ADDENDUM # 2

For RFP # 6284

SUBJECT: Response to Proponent questions and clarifications

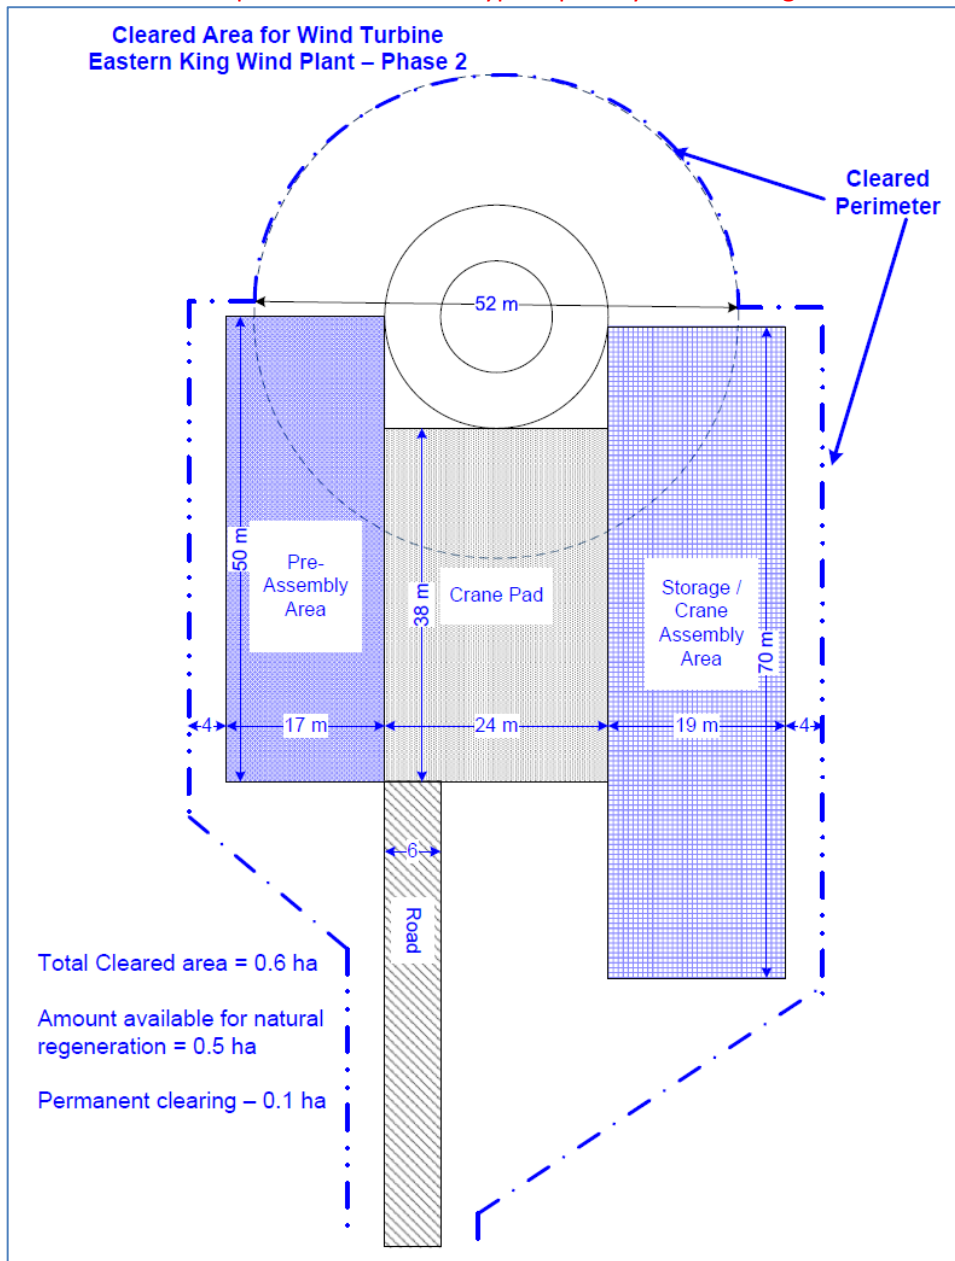
Question #5 - Will sufficient space be available at each wind turbine pad for full storage of components?

Yes. Civil road and crane pad designs were based on current Enercon civil requirements and will be available to the Proponent. Please see typical pad laydown arrangement.
